Annex 5: HW change description v1.2 to Test Report 20-1-0017102T02a-A5

1 LOCU1xxx HW change description v1.2

Hardware change description
SICK LOCU1xx – UWB TAG

v1r3 -> v1r3.1 change description

Details for changes of LOCU Battery Basic/Advanced bottom layer:

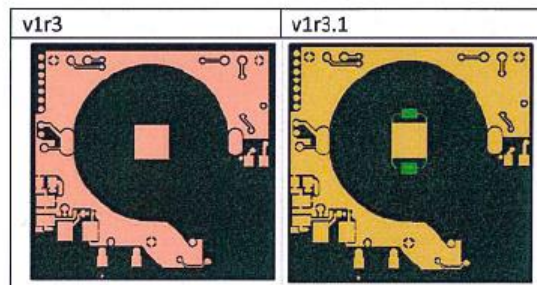
1. Battery holder: Pad adjustment of negative battery contact- milled grooves for battery holder are shifted in v1r3.1 comparing to v1r3. The pitch of grooves is increased by 0,45 mm.

- red mark - v1r3
- green mark - v1r3.1

2. Negative battery contact: Additional negative battery contact (Keystone 2991) added to v1r3.1:

RF performance is not affected, since antennas are on top side of the PCB, which is shielded by ground plane in the inner layer from the slightly adjusted bottom layer.
